## ADDENDUM NO. 2

Project: BL299 Willkie C – Add Willkie Building to the Campus Chilled Water Loop  
IU 20230167

Date: May 9, 2025

**C201**

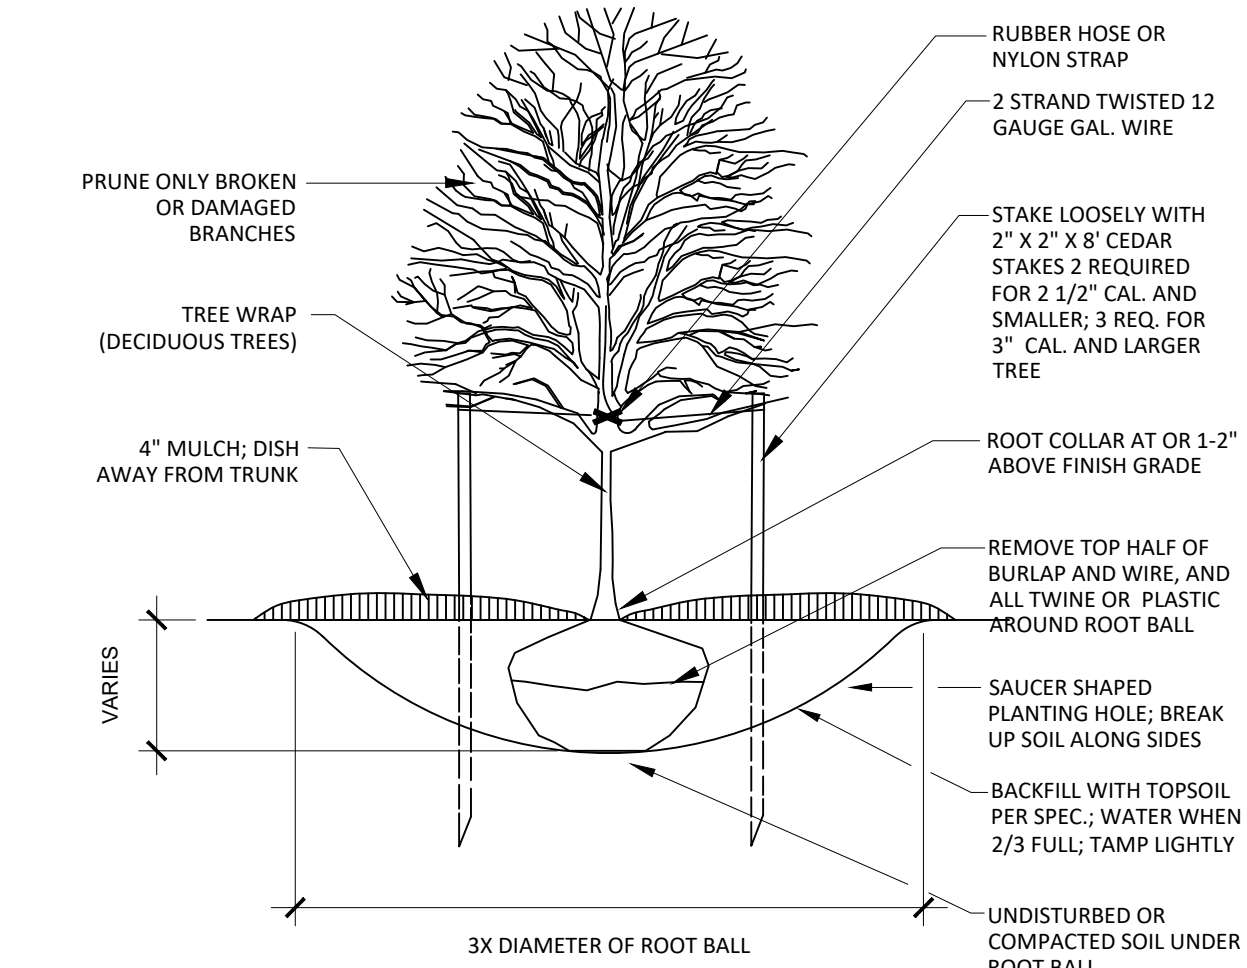
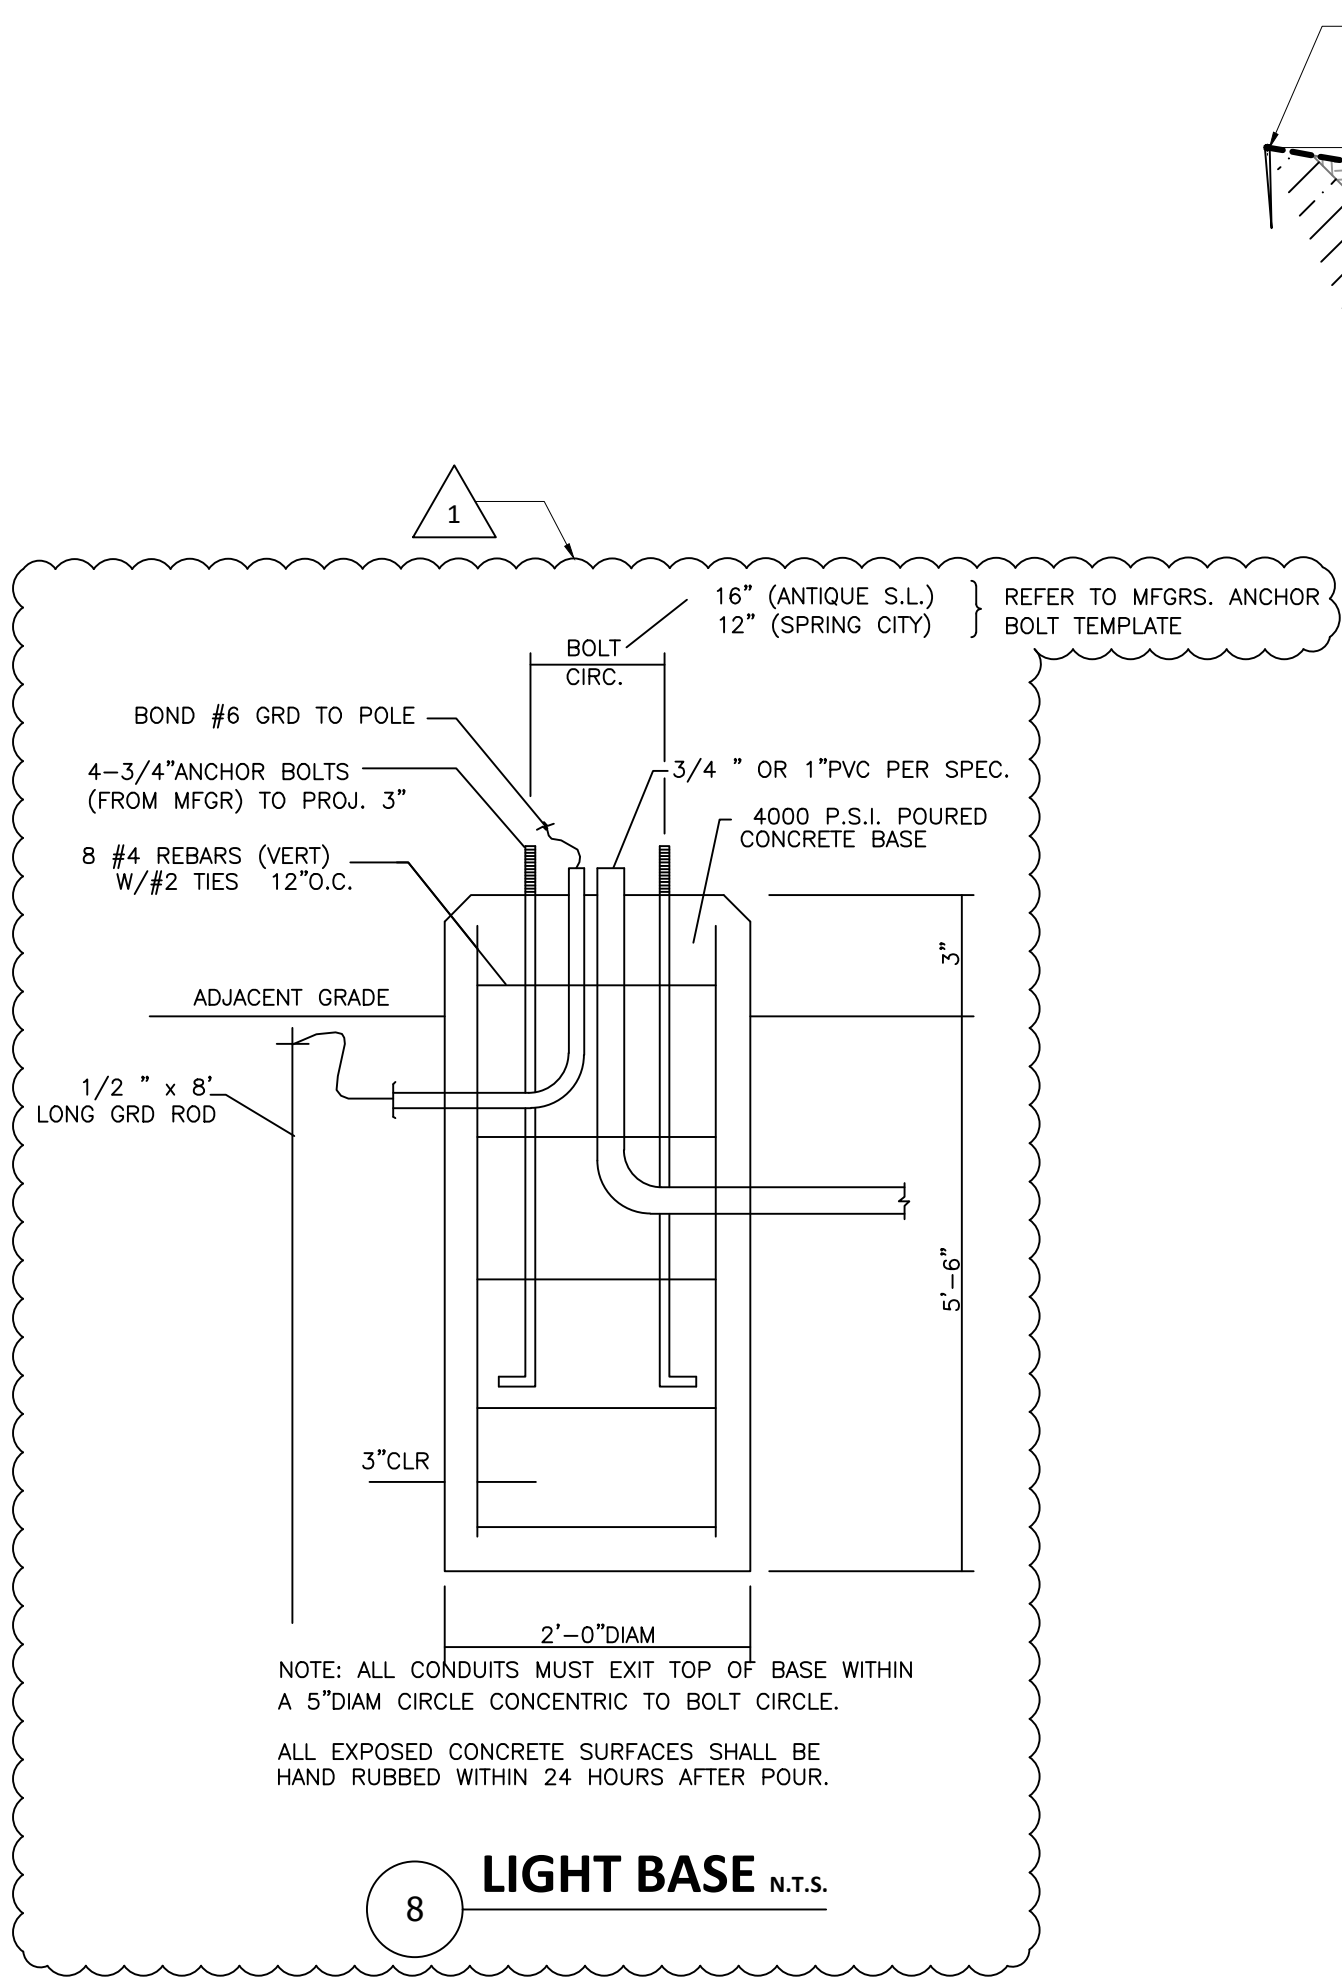
*Q1: The majority of this project shows the construction fence roughly 10 - 12 ft wide. With the minimum width of the trench and OSHA standards requiring another 2' away from the ditch line (leading edge) for laborers to work away from the ditch line on both sides - Not to mention rock excavation – can more width be provided? Utility contractors typically have a minimum of 20'.*

*Q2: If the contractor has to cut and excavate additional concrete walk paths beyond the limits of what is currently shown on the plans, are they going to be entitled to a PCO?*

Sheet C201 – Selective Site Demolition, Restoration, & Erosion Control Plan

- MODIFY temporary site protection fencing
- MODIFY hard surface remove/replacement limits

*A1: The temporary site protection fencing has been widened to wherever possible, considering the site constraints. Refer to attached - revised sheet C201 Selective Site Demolition, Restoration, & Erosion Control Plan.*

*A2: The limits of concrete and asphalt removal and replacement have been revised to be more realistic, but should not be interpreted as the exact limits of demolition and restoration. Refer to sheet C201 Selective Site Demolition, Restoration, & Erosion Control Plan, General Note D, regarding the limits of demolition and replacement.*
